Staff Report

Infill Housing Design Review Committee

File Number: 5-A-21-IH

Location: 2504 Harvey St. **Parcel ID** 81 F B 044
Zoning: RN-2 (Single-Family Residential Neighborhood)
District: Oakwood/Lincoln Park Infill Housing Overlay District

MAIN FLOOR PLAN

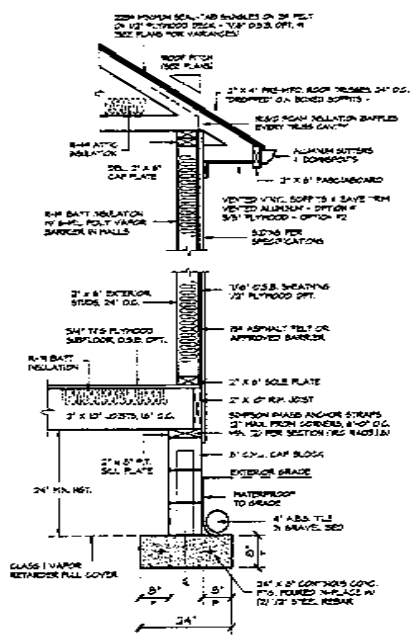
5. The site plan depicts an 8' front porch, while floor plan drawings show a 6' deep porch; this discrepancy should be addressed. A wood deck is shown on drawings, but not on the site plan. Final site plan should reflect what will be built. The half-width, front-gable roof porch will be consistent with the similarly-sized, projecting, front-gable roof porches on the remainder of the block.

- 1) Modify front setback to be more consistent with adjacent properties;
- 2) Add a walkway from the front door to the sidewalk;
- 3) Parking to meet City Engineering requirements (including modified placement on west side of lot);
- 4) Verify foundation height to be consistent with historic properties;
- 5) Locate an additional window on the right elevation and omit non-operable façade shutters;
- 6) Exterior siding to be lap siding with an overlap instead of Dutch lap or flush panels;
- 7) Incorporate one native or naturalized tree in both front and rear yards.
